SUBJECT: (Emergency Permit) NOD-20  
BASE FILE: MVN-2010-1271-EOO

Department of the Army Permit Evaluation  
And Decision Document

Application No.: MVN-2010-1271-EOO

Emergency Authorization Request under NOD-20 (Deepwater Horizon Oil Discharge)

QUATRE BAYOU ROCK DIKE  
PLAN VIEW

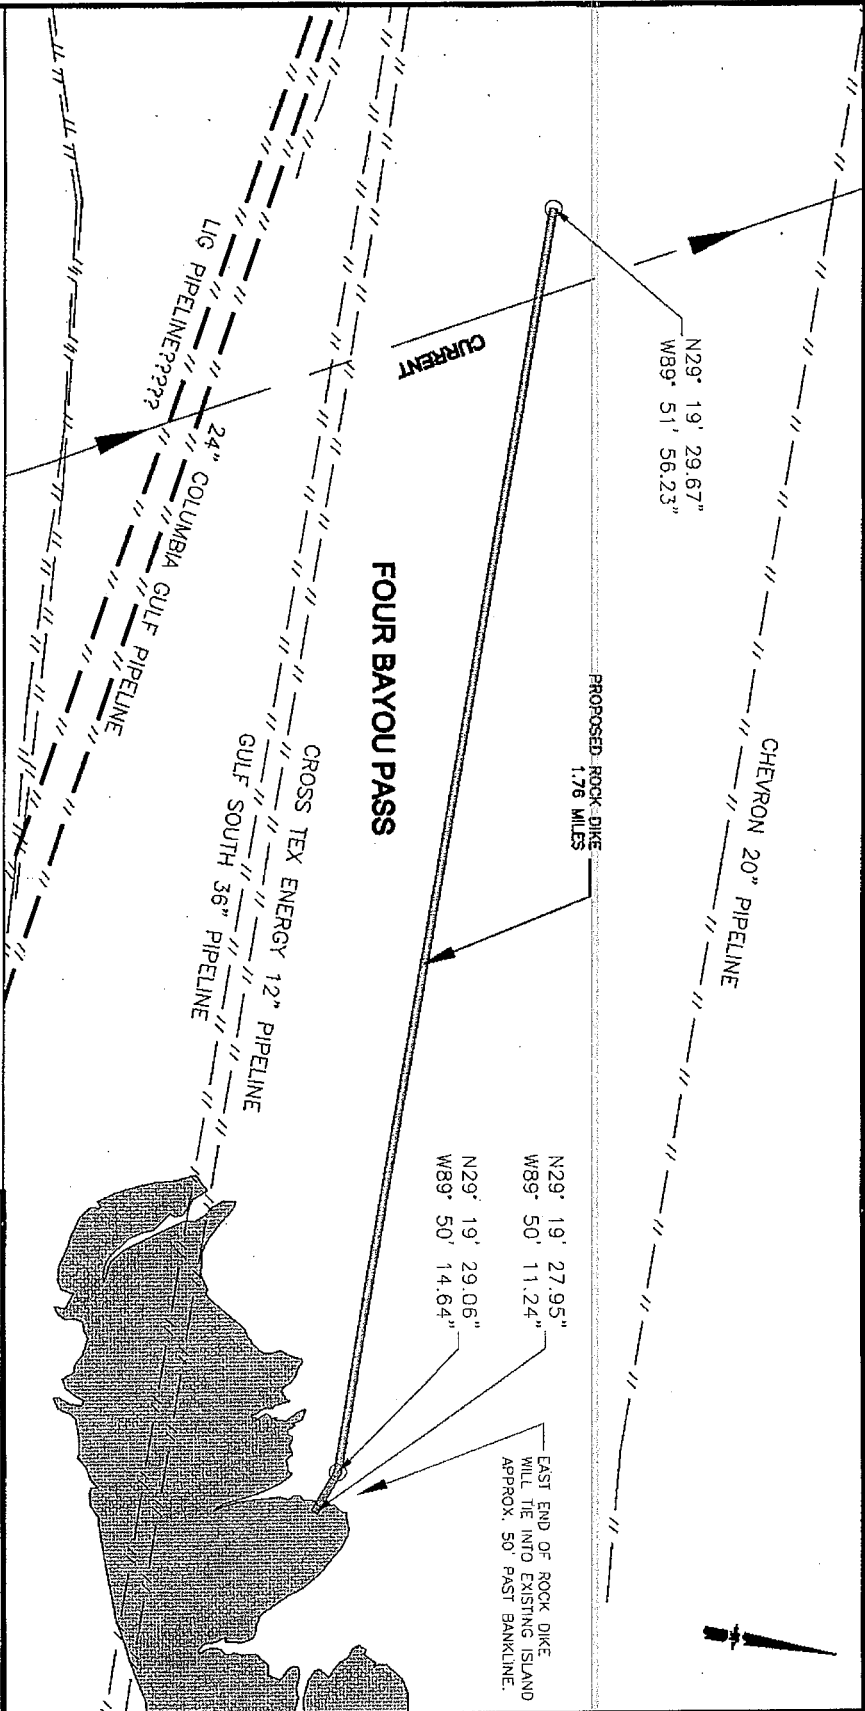
1.1	Submit detailed plans for the rock tie-in points at Pass Abel and Four Bayou Pass: address the eastern tie end of the rock jetty @ the island on the east side of Four Bayou Pass	●							Shaw has developed tie in details for both of the proposed passes. At Pass Abel, the dike will tie into the recently constructed East Grand Terre dune. As this dune is higher than the proposed rock structure, the proposed rock structure will be overtopped first in the event of a storm surge, thus minimizing scour of the existing island. In addition, a scour blanket will extend around the tie in to the -1 ft NAVD contour. For Four Bayou Pass, topographical highs were identified using existing lidar information. The rock dike will extend 50 ft onto the island at the high spot. Topographical surveys will be performed to verify the location and elevation of the tie in. A scour blanket will extend from the tie in to the -1 NAVD contour. Details of the proposed tie-ins are attached.

4.15	Increased velocities associated with a storm surge could cause breaching on or near the transition points where the proposed rocks connect with existing islands. This would be similar to what occurred at levee transition points during hurricane Katrina.			●		●		See attached design for end-point detail.

Figure 1 pre-post velocity profiles and impacts on operations

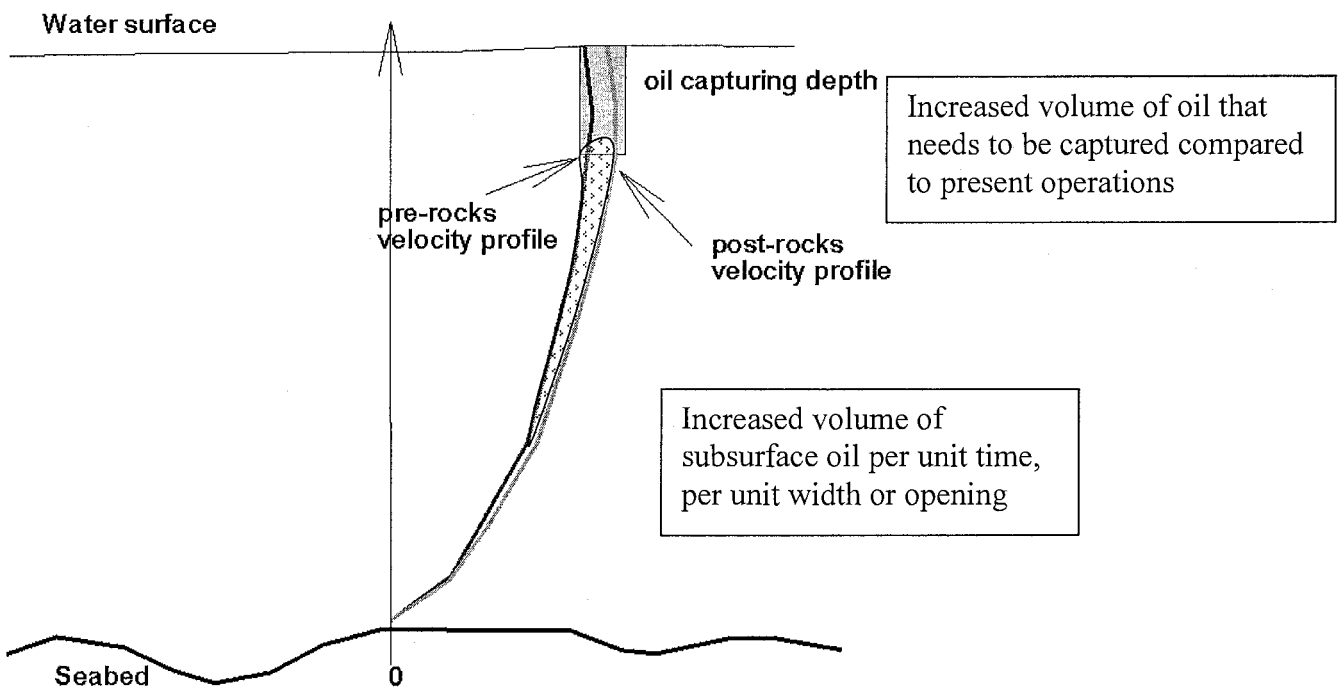
- a. The faster currents will change the velocity profile (figure 1), and inadvertently increase the volume that skimmers would have to pump, per unit time during flood currents (gray box in fig 1)

- b. The area below the gray box, integrated and subtracted from the pre-rock placement profile, would also increase the amount of subsurface oil coming through these inlets.

USACE	USFWS	EPA	CPRA	NOAA	H-SERT	CRCL et al	
3.13	Figure 1 pre-post velocity profiles and impacts on operations (Ioannis Georgiou)						●		
3.14	<p>Figure 1: pre-post velocity profiles and impacts on operations</p>								<p>Response to 3.13-3.16:</p> <p>2.18. We appreciate the opportunity to use of the sketch prepared by Dr Ioannis Georgiou to explain the mechanics of possible reduction of oil propagation through the Passes. Maximum velocities (V) at the passes without barrier are in excess of <u>4 ft per second</u>. The passes are very wide: Pass Abel is more than 7,000 ft in width. One can compute a possible huge amount of oil that currently or in the future can <u>propagate into the bay</u>. Excluding velocities for most of the length of the pass (making V=0 and making B post &lt;&lt;&lt; B pre-project would exclude a significant amount of oil from entering the pass.</p> <p>In addition, modeling showed that construction of the dike would reduce in more than a 65% decrease in the flow volume at Pass Abel (<math>V \cdot B \cdot C</math>; the total amount of water and oil that enter the bay) and more than a 35% reduction in volume at Quatre Bayou Pass. This means that there is an overall reduction of the oil entering the bay through these passes.</p>
